March 19, 2013

From: Anthony Montoya, Jr., P.E., Chief Engineer,  
Albuquerque Bernalillo County Water Utility Authority

Subject: City of Albuquerque Standard Specifications for Public Works Construction  
Amendment 1 to Update 8  
Albuquerque Bernalillo County Water Utility Authority  
Revisions, Deletions, and Additions - Summary

REVISIONS	WATER AUTHORITY
	<b>SANITARY SEWER CONCRETE MANHOLE TOP SLAB TYPE "C"</b>
	DWG. 2107 <span style="float: right;">JAN. 2013</span>

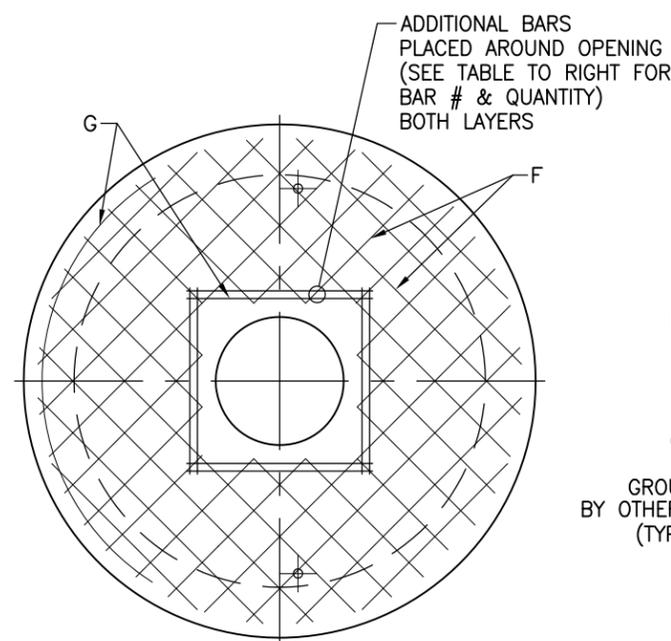
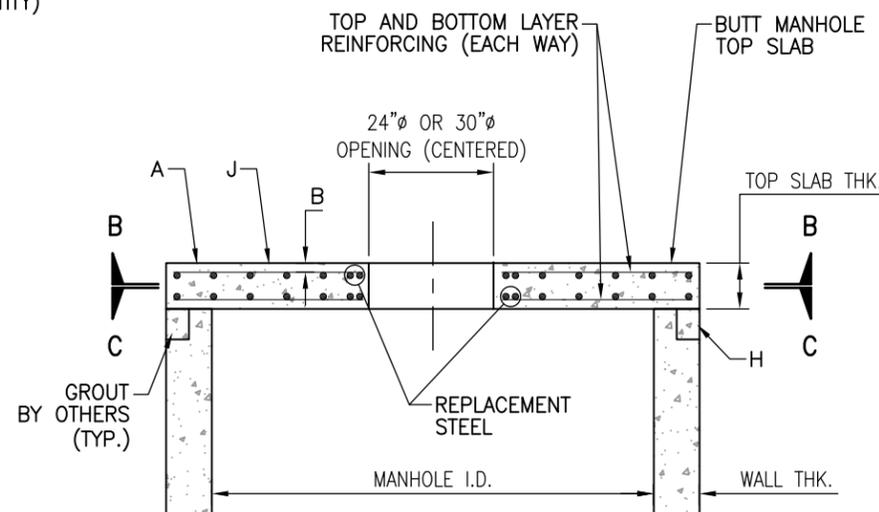
- 2107 NEW DETAIL – Sanitary Sewer Concrete Manhole Top Slab Type "C". This detail shows the opening centered over the top of the manhole rather than the side as shown on the older detail which has been moved to the Drainage Section detail No.2212;

REVISIONS	WATER AUTHORITY
	<b>VACUUM SEWER CASING DETAIL FOR BORE AND JACK</b> DWG. 2180 <span style="float: right;">JAN. 2013</span>

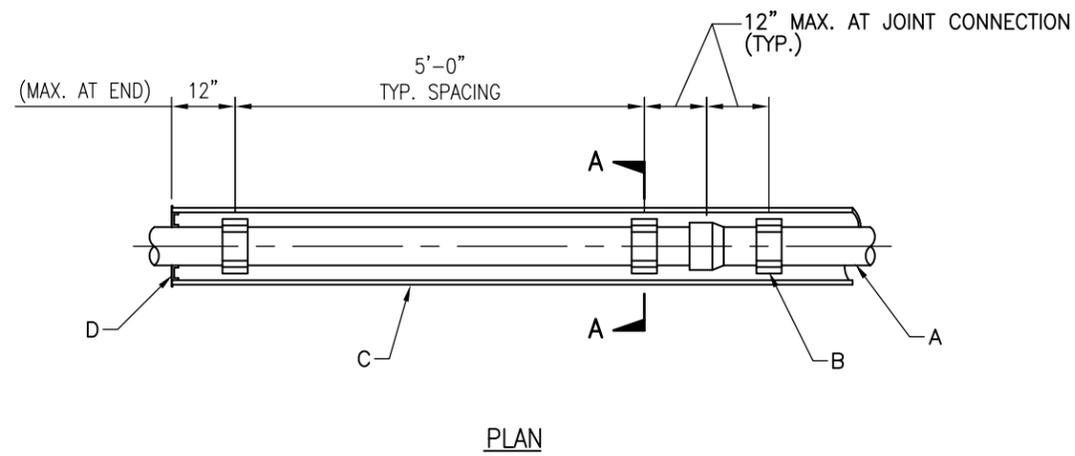
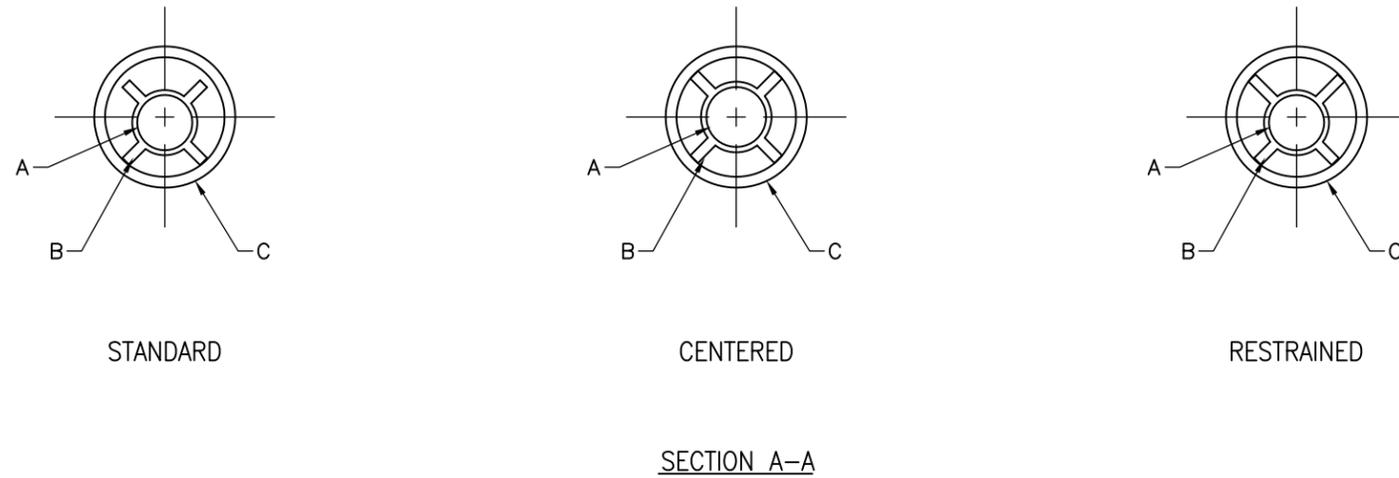
- 925.5.2.12 Addition of reference to Standard Detail Drawing 2180 Casing Detail for Bore and Jack Vacuum Sewer System to the installation specification of pipe through a casing;

- 925.5.6 Addition of reference to Standard Detail Drawing 2180 Casing Detail for vacuum main or force main installation;
- 925.5.7 NEW Air Release Valve Installation subsection;

REVISIONS	WATER AUTHORITY
	FORCEMAIN SEWER VALVE BOX
	DWG. 2181
	JAN. 2013

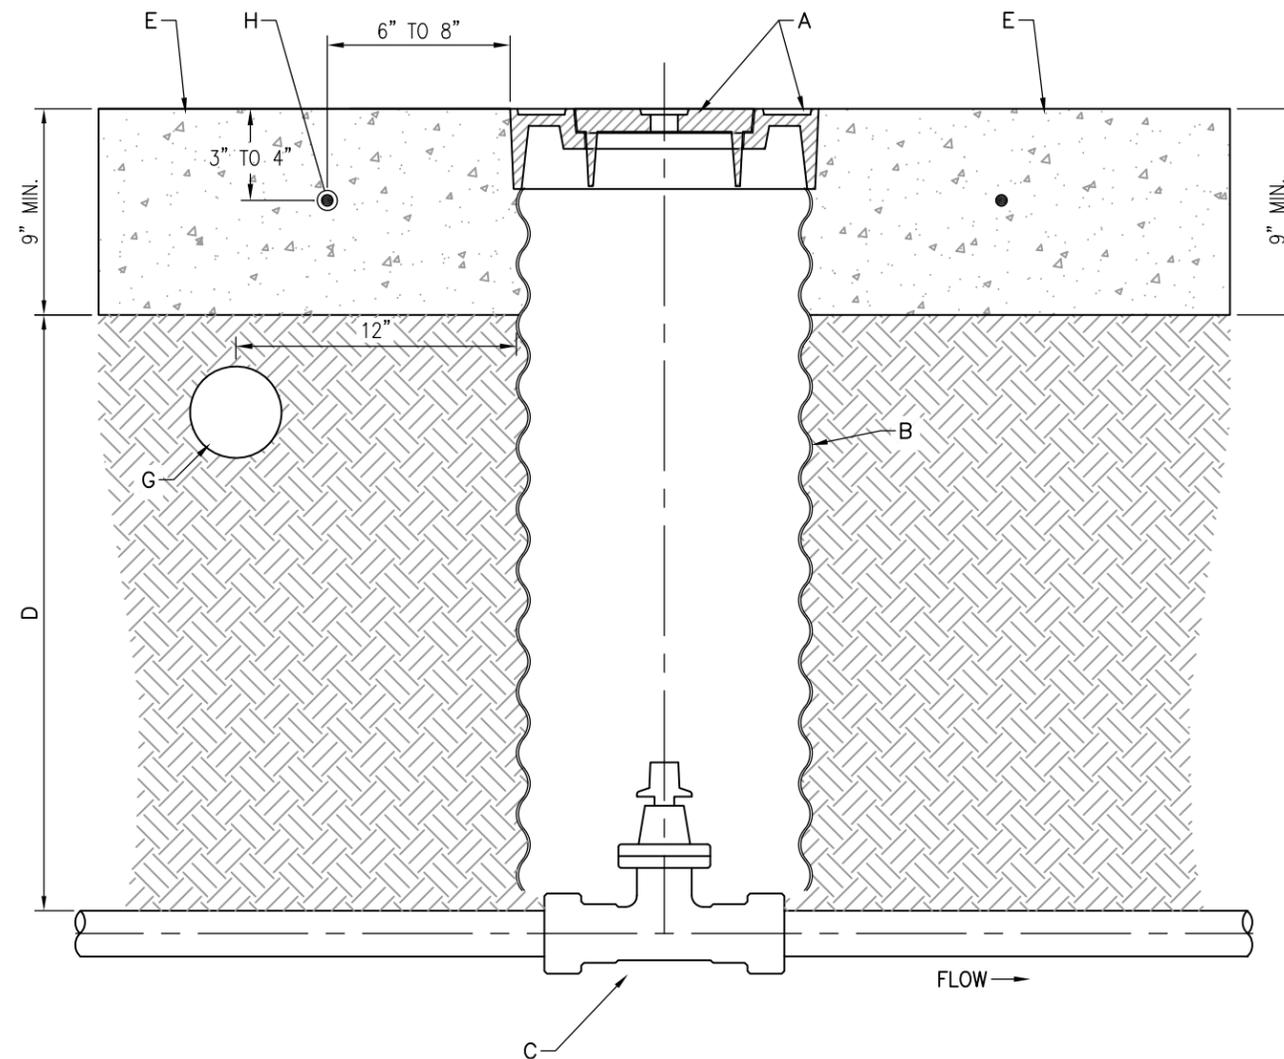
Drawing 2107, 2128, 2170, 2181, 2182, 2183, 2184, and 2185 are new details that were added to the section;  
Drawings 2110 and 2111 were moved to Section 2200 Drainage Detail Drawings;  
Drawings 2151 and 2172 were removed;

REVISIONS	WATER AUTHORITY
	WATER VALVE BOX
	DWG. 2326
	JAN. 2013

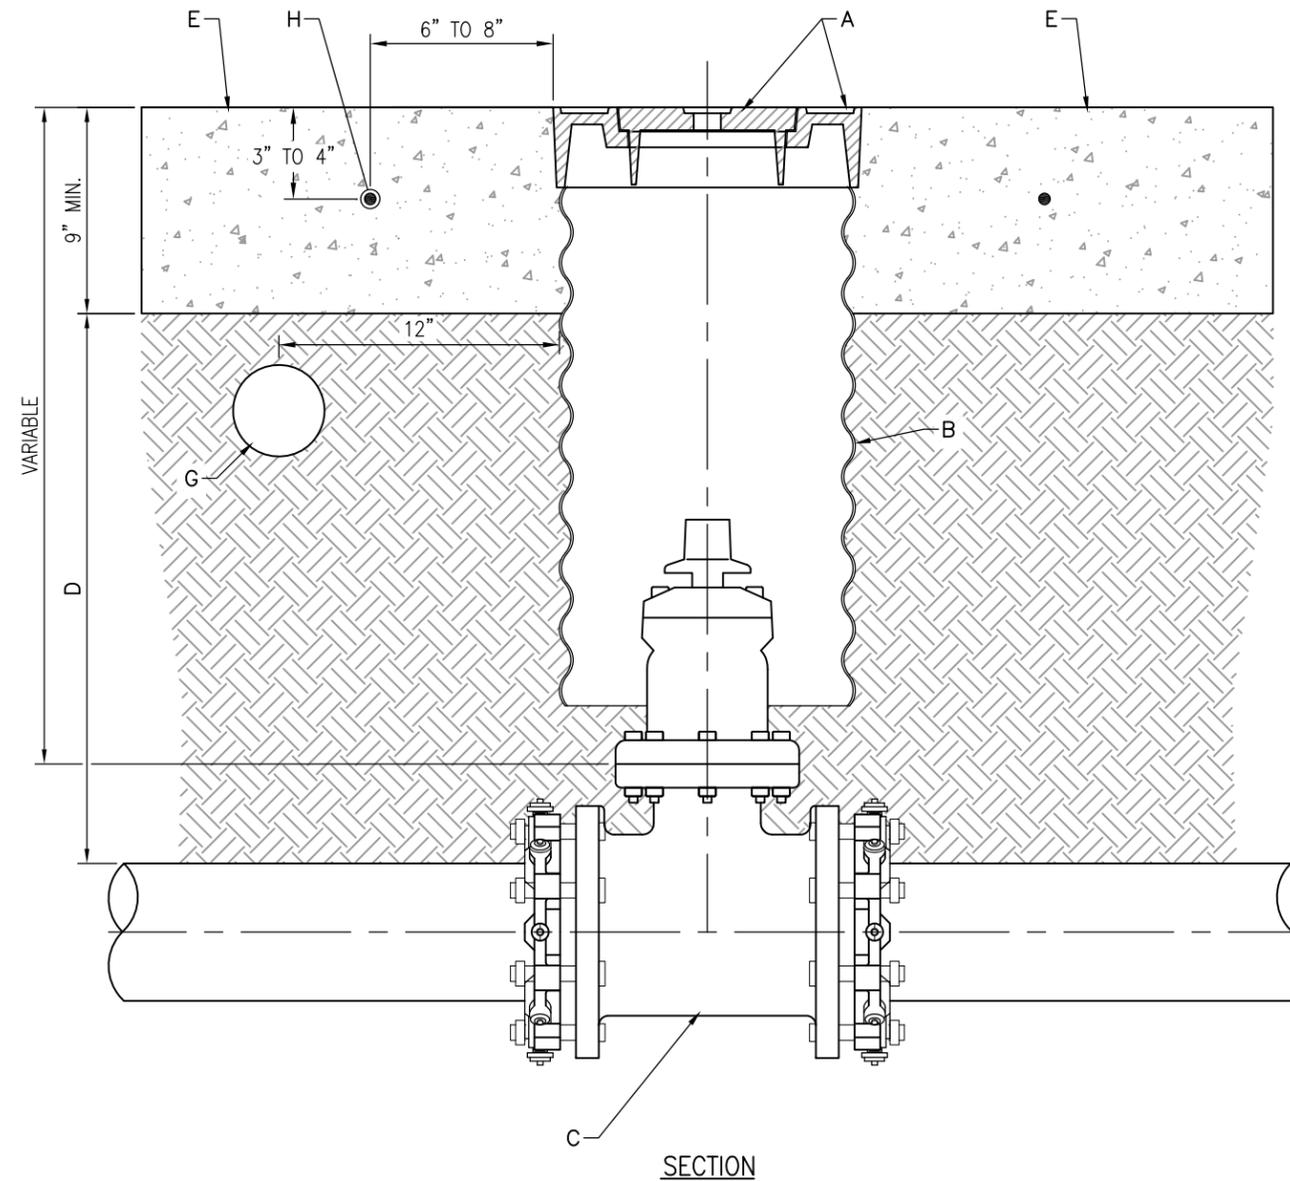
- 2310 The 24” water manhole cover has been eliminated; A 36” water manhole is now used;
- 2321 NEW Detail – WATER CONCRETE ENCASEMENT DETAILS;
- 2322 NEW Detail – WATER STATIONARY POST DETAIL
- 2326 WATER VALVE BOX – Change/clarification to Construction Note A to require FIRE Ring and Cover (detail 2329) on fire line valve boxes; Rebar has been added to the concrete collar;
- 2328 Minor General Notes cleanup;

REVISIONS	CITY OF ALBUQUERQUE
	<b>MANHOLE/VALVE CONCRETE COLLAR DETAIL</b>
	DWG. 2461 <span style="float: right;">JAN. 2013</span>

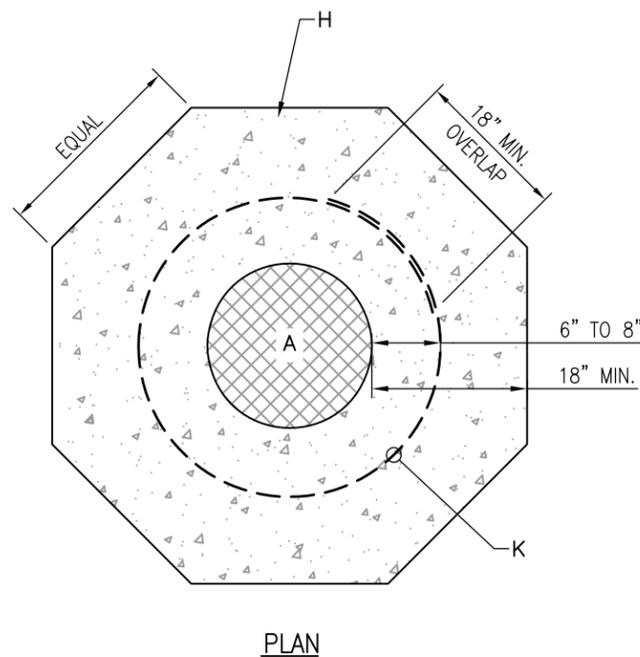
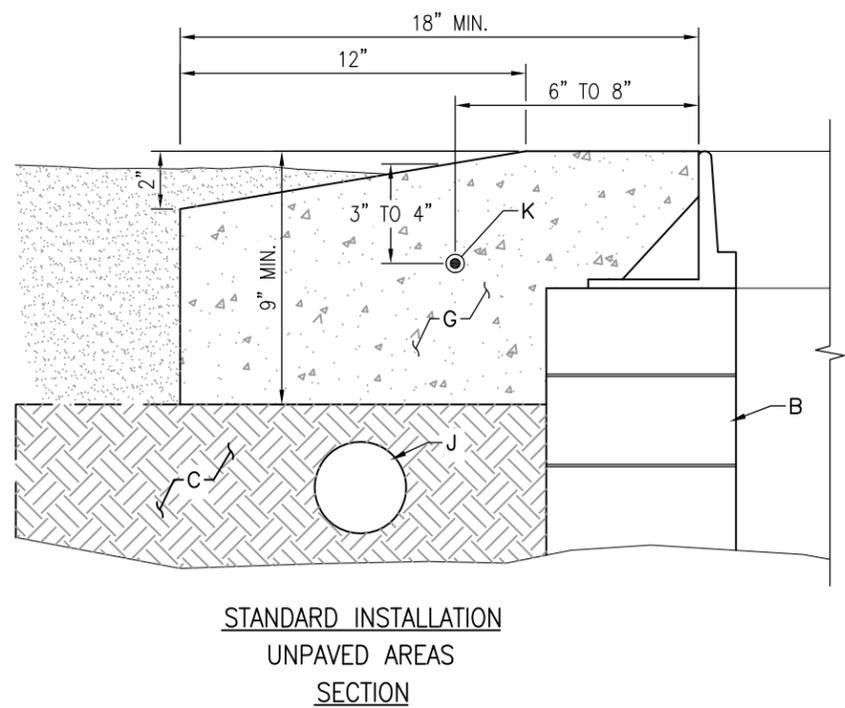
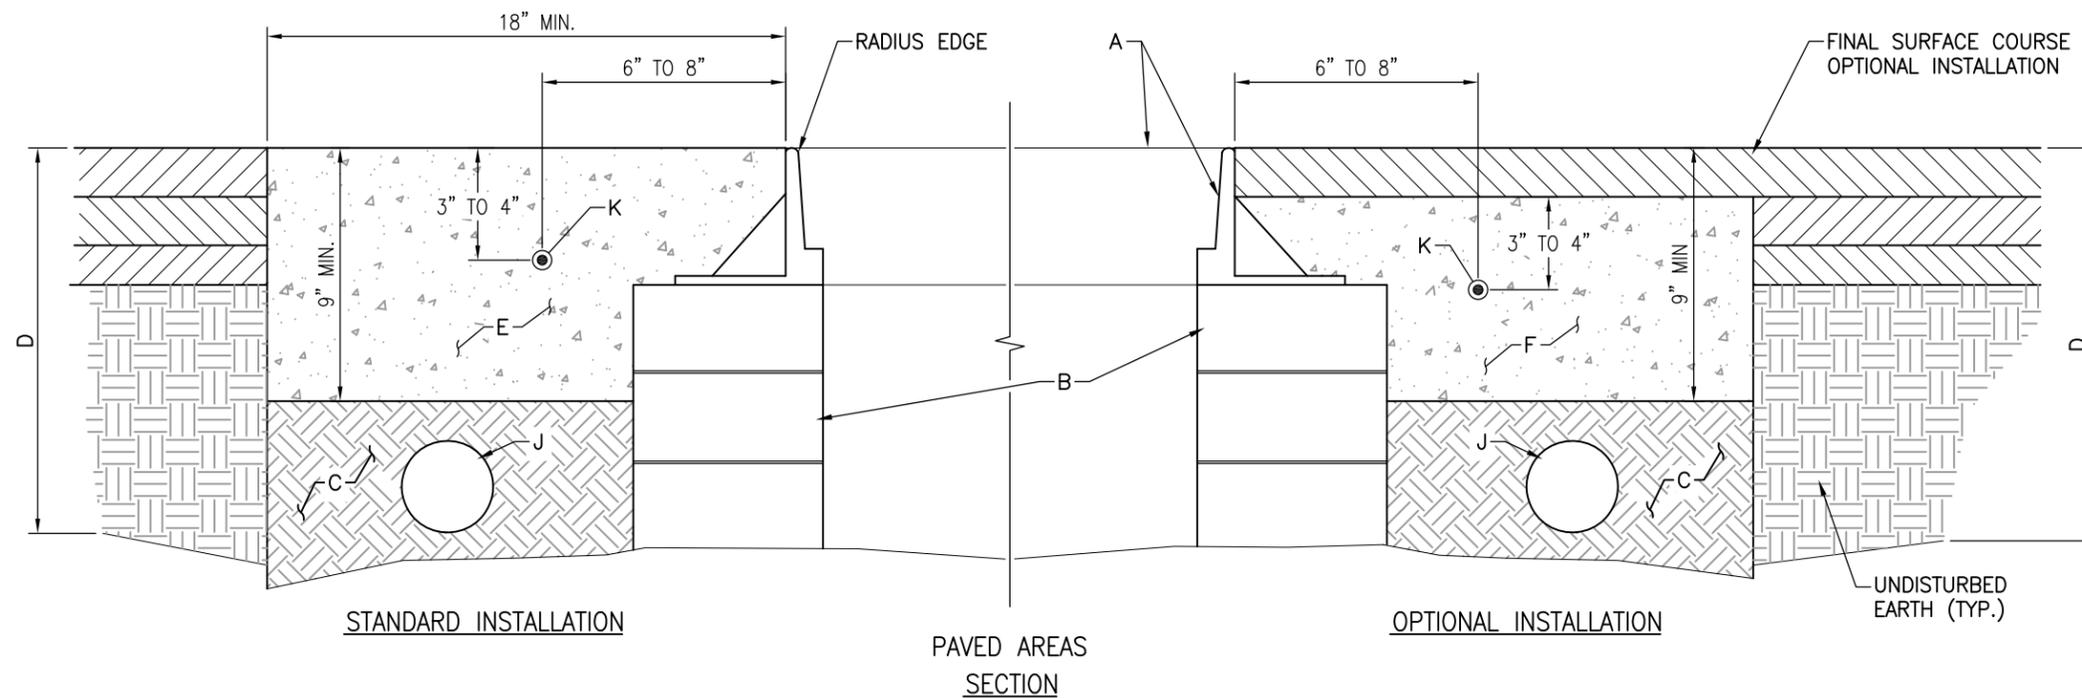
- 2460 Water valve concrete collar detail revised to match geometry of detail 2461; Rebar in the collar is shown;
- 2461 – Addition of rebar around manhole and valve concrete collar; Correction to Note D: change “PAYING” to “PAVING”
